INITIAL FIRE SAFETY INSPECTION REPORT

GAVA PRIVATE LIMITED

RSC ID: 26131

Date: 26 August, 2025

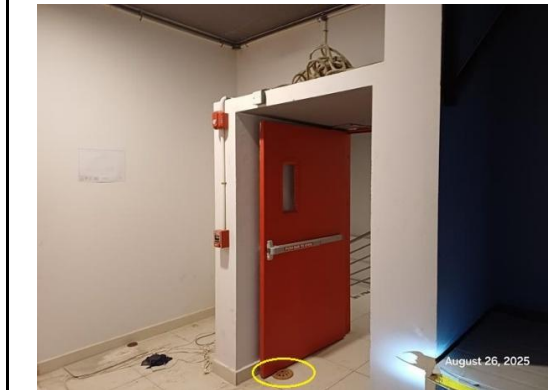
SI No.	Category	Findings	Required Action	Remediation Time Frame
F2	Means of Egress	The exit stair enclosures are not separated from work areas and other spaces on each floor by fire-rated construction. Non-Compliance Reason: The fire doors were found tied by unauthorized means and also interfacing with the fire alarm system & door closers were not properly functional during the inspection. Proper certification was not available for fire rated doors and door accessories installed in the factory. Location: Stair-1 and Stair-2 on all floors of Office Building-1	The exit stair enclosure shall be provided with a minimum 1-hr fire resistance rating for buildings with 3 or fewer stories and a minimum of 2-hr. fire resistance rating for buildings 4 or more stories. Provide 1-hr. fire rated door and seal all penetrations and openings by 1 hr. fire rated fire rated barrier construction for building with 3 or fewer stories. Provide 1.5 hr. fire rated door and seal all penetrations and openings by 2 hr. fire rated fire rated barrier construction for building with 4 or more stories in accordance with section 6.3.1.2 of RSC Technical Guidelines (Standard)¹ V1.0. Ensure that the fire doors are self-closing and positive latching and that they are provided with fire exit (panic) hardware where serving production floors. If fire doors are required to be held open for functional reasons, provide automatic closing devices tied to the fire alarm system. Keep proper datasheet & certifications for installed fire doors & accessories on-site for verification. The clearance under the bottom of a door shall be a maximum of 3/4 in. (19 mm).	Within 3 Months

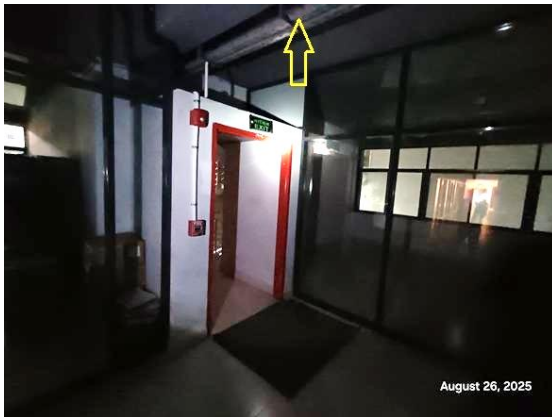
SI No.	Category	Findings	Required Action	Remediation Time Frame
F4	Fire Rated Construction	Areas used for in-process storage of combustible materials are open to the surrounding occupancy. Location: Ground floor of Office Building-1	Provide defined storage areas and limit the storage arrangement as follows: Maximum height of 2.45 m and maximum area of 23 m² and is separated by a minimum 3.0 m (10ft) from other storage areas and they do not exceed 10 percent of the building area of the story in which they occur. or, If sprinkler protected, Maximum height 12 ft (3.66 m) and maximum area of 1000 ft² (93 m²) and separated by a at least 25 ft (7.62 m) and does not constitute more than 10 percent of the building area or 4000 ft² (372 m²) of the sprinklered area, whichever is greater. or, Enclose the storage area from the surrounding occupancy with a minimum 1 hour construction.	Within 3 Months

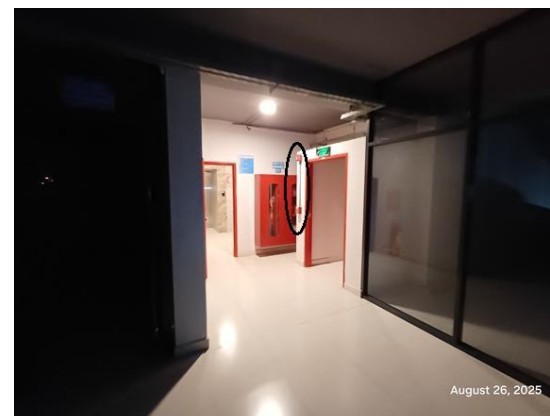
SI No.	Category	Findings	Required Action	Remediation Time Frame
F6	Fire Alarm & Detection system (ITM of FADS)	Inspection, testing and maintenance for the fire alarm system is not in accordance with NFPA 72 and The RSC Technical Guidelines (Standard). Location: Building-1 Whisker Shed	Inspect, test and maintain the fire alarm system and keep written records on-site, in accordance with NFPA 72 and The RSC Technical Guidelines (Standard) and keep written records on-site	Within 1 Month (after installation)
F7	Means of Egress	Aisles are found missing on 1st floor of office building-1 as placement work of new machines were ongoing . Location: 1st floor of Office Building-1	Provide minimum aisle widths of 36-in. Aisles mark shall be clearly visible.	Within 1 Month

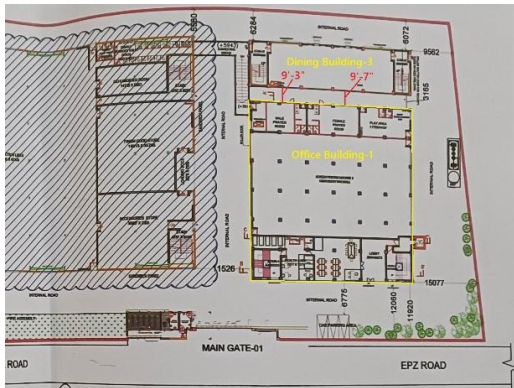
SI No.	Category	Findings	Required Action	Remediation Time Frame
F10	Means of Egress	Based on the number and location of emergency lights observed, adequate illumination levels are not anticipated along egress routes. Location: All floors of office building-1	Test the emergency lighting system on each floor and provide additional emergency fixtures to provide adequate illumination along the means of egress. Provide a minimum illumination of 10 lux at the floor level within exit stairs and exit discharge paths and minimum 2.5 lux along exit access aisles. Illumination on means of egress shall meet in accordance with RSC Technical Guidelines (Standard)¹ V1.0 Section 10.12.2.	Within 3 Months

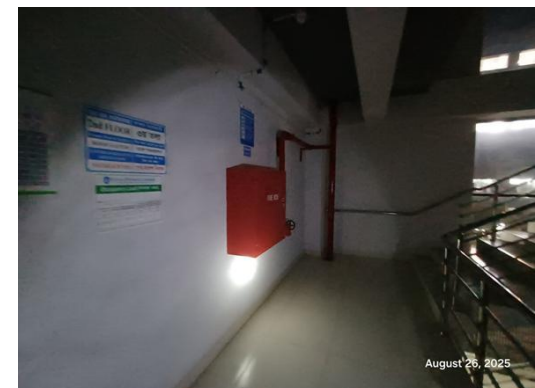
SI No.	Category	Findings	Required Action	Remediation Time Frame
F11	Means of Egress	Directional signs are not provided where direction of the path of travel to an exit has changed. Exit signages are not illuminated during testing (burned out, broken, etc.). Location: 1st and 2nd floor of Office Building-1	Lighted exit signs shall be placed at entrance to an exit. Additional directional exit signs shall be placed throughout the facility anywhere the continuation of the egress is not obvious. Lighted exit signs shall be provided with either battery backup or uninterruptable power supply systems and shall be continuously illuminated at all times. Exit Sign shall provide in accordance with RSC Technical Guidelines (Standard)¹ V1.0 Section 6.11.	Within 1 Month

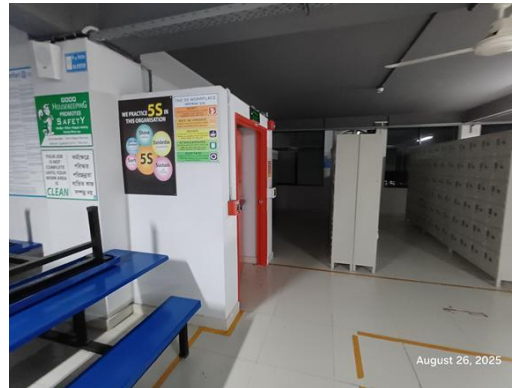
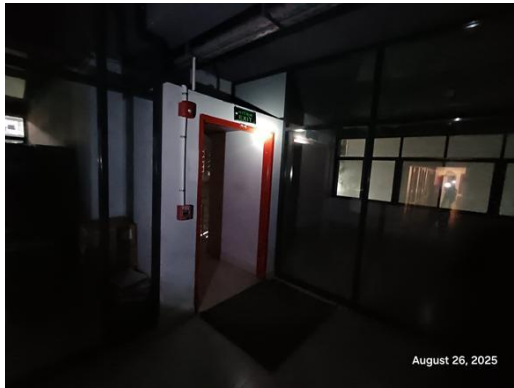
SI No.	Category	Findings	Required Action	Remediation Time Frame
F12	Inspection, Testing & Maintenance (Emergency lighting system)	Inspection, testing, and maintenance for the exit sign and emergency lighting system was not in accordance with the RSC Technical Guidelines (Standard) ¹ V1.0.	Inspect, test and maintain the exit sign and emergency lighting system in the accordance with the RSC Technical Guidelines (Standard) ¹ V1.0. Keep written records on-site.	Within 1 Month
F13	ITM of Fire Extinguishers	Inspection, testing and maintenance of portable fire extinguishers is not in accordance with NFPA 10.	Inspect, test and maintain the portable fire extinguishers and keep written records onsite, in accordance with NFPA 10 and The RSC Technical Guidelines (Standard).	Within 1 Month
F14	Means of Egress (Guard rails or parapet wall)	Parapets or guards are not provided as per standard in occupiable roof. Location: Office Building-1	Provide parapets or guards with a minimum height of 1067mm (42 inch.) in accordance with RSC Technical Guidelines (Standard) ¹ V1.0 Section 6.12.	Within 3 Months

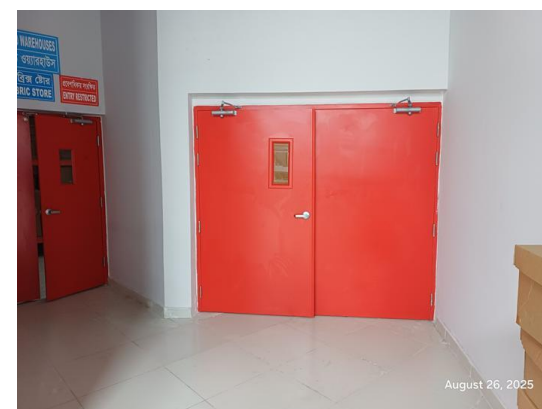
SI No.	Category	Findings	Required Action	Remediation Time Frame
F23	Fire Rated Construction	Penetrations through floor/ceiling assemblies are found unsealed due to electrical cable riser and plumbing PVC Pipes. Location: DB room in all floors, Toilet zones east side of main production building-2. Non-compliance Reason: For electrical & plumbing penetration Shaft is constructed, but there are horizontal penetration in rated wall.	Seal all penetrations and openings in floor/ceiling assemblies by a listed through-penetration fire stop system tested in accordance with ASTM E814 or approved alternative standard to maintain minimum 2-hr. fire resistance rating. Installation shall be as per manufacturer published installation guideline and the certification authority guideline to ensure the fire-rating in accordance with section 4.7 of RSC Technical Guideline (Standard) Or, Provide a minimum 2-hr fire rated shaft to separate the penetration from each floor if required.	Within 3 Months

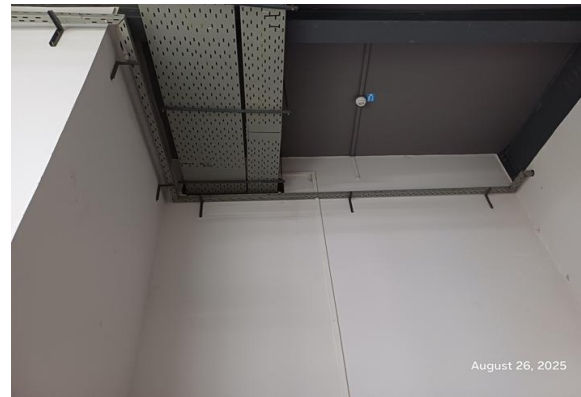
SI No.	Category	Findings	Required Action	Remediation Time Frame
F24	Fire Rated Construction	Rooms used for storage of combustible materials are not separated from the surrounding occupancy. Location: Raw materials store and finished goods store on ground floor of Main production building-2. Non-Compliance Reason: (i) Unprotected steel structural element is found in all lift enclosure; (ii) Proper certification is not available for fire rated doors and door accessories installed in the factory. & (iii) The fire doors were not interfaced with FACP.	Rooms used for storage of combustible materials shall be separated from the surrounding occupancy with a minimum 1 hour construction in accordance with section 3.4.2.1.5 of RSC Technical Guideline (Standard).	Within 3 Months

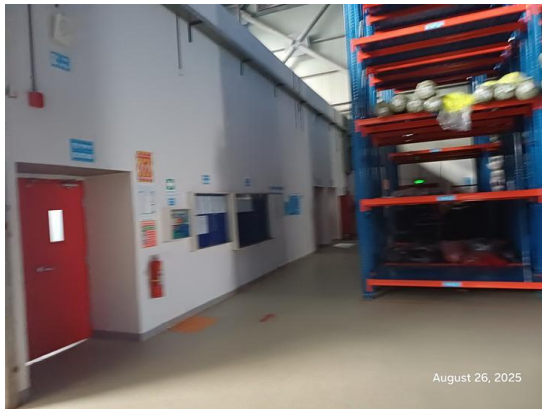
SI No.	Category	Findings	Required Action	Remediation Time Frame
F25	Fire Rated Construction	Areas used for in-process storage of combustible materials are open to the surrounding occupancy. Location: On ground and 1st floor of Main Factory Building-2	Provide defined storage areas and limit the storage arrangement as follows: Maximum height of 2.45 m and maximum area of 23 m² and is separated by a minimum 3.0 m (10ft) from other storage areas and they do not exceed 10 percent of the building area of the story in which they occur. or, If sprinkler protected, Maximum height 12 ft (3.66 m) and maximum area of 1000 ft² (93 m²) and separated by a at least 25 ft (7.62 m) and does not constitute more than 10 percent of the building area or 4000 ft² (372 m²) of the sprinklered area, whichever is greater. or, Enclose the storage area from the surrounding occupancy with a minimum 1 hour construction.	Within 3 Months

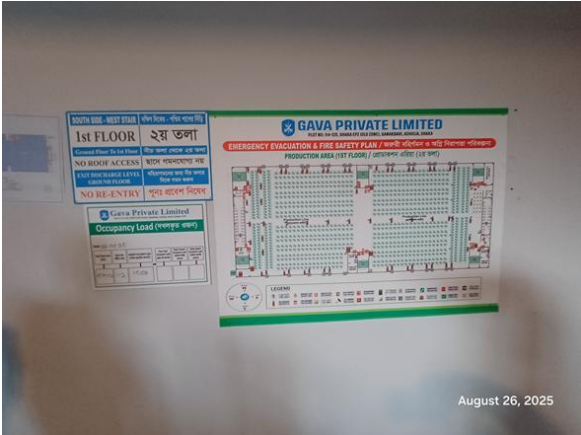
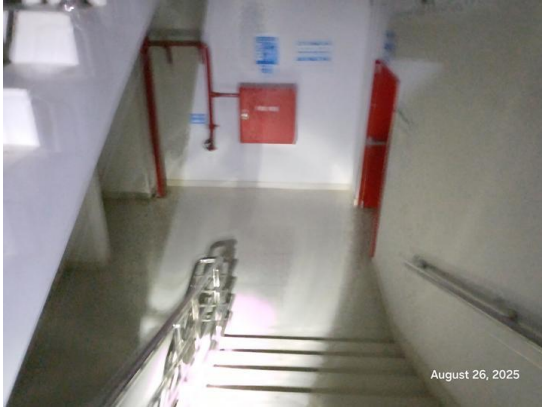
SI No.	Category	Findings	Required Action	Remediation Time Frame
F-34	Means of Egress (Evacuation plan)	Fire evacuation maps are not updated as per site condition due to placement work of new machines were ongoing . Location: 1st & mezzanine Floor of Main Production building-2	Update the fire evacuation map and shall be posted at the entrance to each exit stair in accordance with RSC Technical Guidelines (Standard) ¹ V1.0 Section 13.3.	Within 1 Month

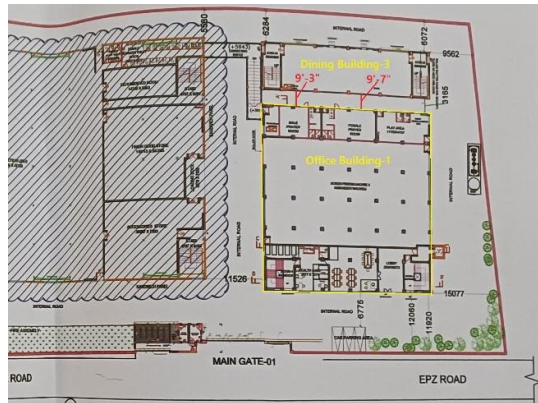
SI No.	Category	Findings	Required Action	Remediation Time Frame
F-38	Fire Rated Construction	A non-rated connecting corridor has been constructed between two buildings which is not fire separated from the adjacent building. Location: Connecting corridor between Production building-2 & Dining building-3 staircase and connecting corridor between Dining building-3 stair & Office building-1.	Separate the buildings with a minimum 2-hour fire-rated construction on both sides of the connecting corridor. Opening protection extending up to 10 feet beyond the connecting corridor shall meet section 4.6 of RSC Technical Guidelines (Standard)¹ V1.0.	Within 3 Months

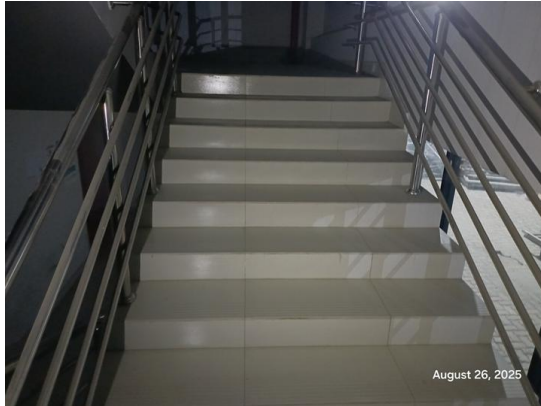
SI No.	Category	Findings	Required Action	Remediation Time Frame
F-41	Fire Alarm & Detection System (FADS)	The factory has installed a fire alarm and detection system that requires a detailed review to confirm compliance with NFPA 72 and RSC Technical Guidelines (Standard). Location (s): Dining Building-3 (G+3), Utility Building-4 (Part-1), Utility Building-5 (Part-2) (G), Building-7 Guard Room-2 (G), Building-6 Guard Room-1 (G), Building-8 Fire Panel Room (G), Building-9 Fire Pump Room & U.G.W.R (G+B), Building-10 Maintenance Workshop (G) and New Waste Store Shed-1 (G)	Submit the fire alarm and detection system design to RSC for review. Once the design is reviewed, install and modify the fire detection and alarm system throughout the building in accordance with review comment, RSC Technical Guidelines (Standard) and NFPA 72. After installation/modification the owner shall conduct internal testing and commissioning and then contact the RSC for witness of final acceptance testing.	Design within 2 month and modification/ installation with 4 months

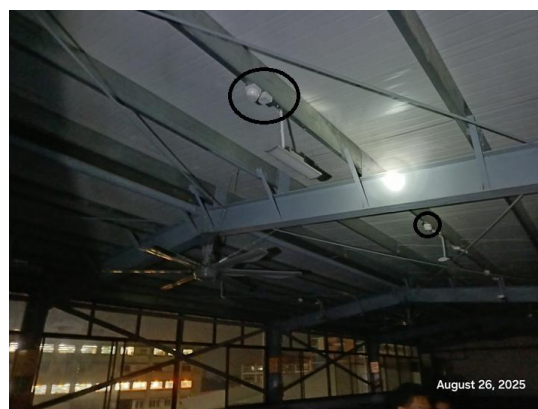
SI No.	Category	Findings	Required Action	Remediation Time Frame
F-42	Inspection, Testing & Maintenance (Fire detection system)	Inspection, testing and maintenance for the fire alarm system is not in accordance with NFPA 72.	Inspect, test and maintain the fire alarm system and keep written records on-site, in accordance with NFPA 72 and RSC Technical Guidelines (Standard) ¹ V1.0.s.	Within 1 Month after installation.
F-43	Inspection, Testing & Maintenance (Portable fire extinguishers)	Inspection, testing and maintenance of portable fire extinguishers is not in accordance with NFPA 10.	Inspect, test and maintain the portable fire extinguishers and keep written records on- site, in accordance with NFPA 10 and RSC Technical Guidelines (Standard) ¹ V1.0.s.	Within 1 Month

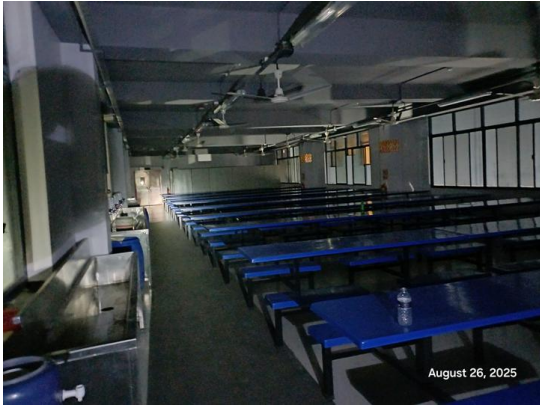
SI No.	Category	Findings	Required Action	Remediation Time Frame
F-47	Means of Egress (Egress Lighting)	Based on the number and location of emergency lights observed, adequate illumination levels are not anticipated along egress routes. Location: All Floor of Dining Building-3	Test the emergency lighting system on each floor and provide additional emergency fixtures to provide adequate illumination along the means of egress. Provide a minimum illumination of 10 lux at the floor level within exit stairs and exit discharge paths and minimum 2.5 lux along exit access aisles. Illumination on means of egress shall meet in accordance with RSC Technical Guidelines (Standard)¹ V1.0 Section 10.12.2.	Within 3 Months

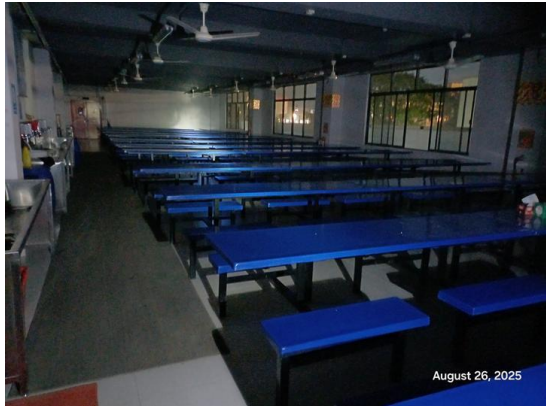
SI No.	Category	Findings	Required Action	Remediation Time Frame
F-48	Means of Egress (Exit Sign, Stair sign & occupant load sign)	Few Exit signs are burned-out, Directional signs are not provided where direction of the path of travel to an exit has changed. Location: All ancillary Structures	Illuminated directional signs shall be provided where there is a change in the direction for the path of travel and the direction to an exit is not obvious in accordance with RSC Technical Guidelines (Standard) ¹ V1.0 Section 6.11.3.	Within 1 Month
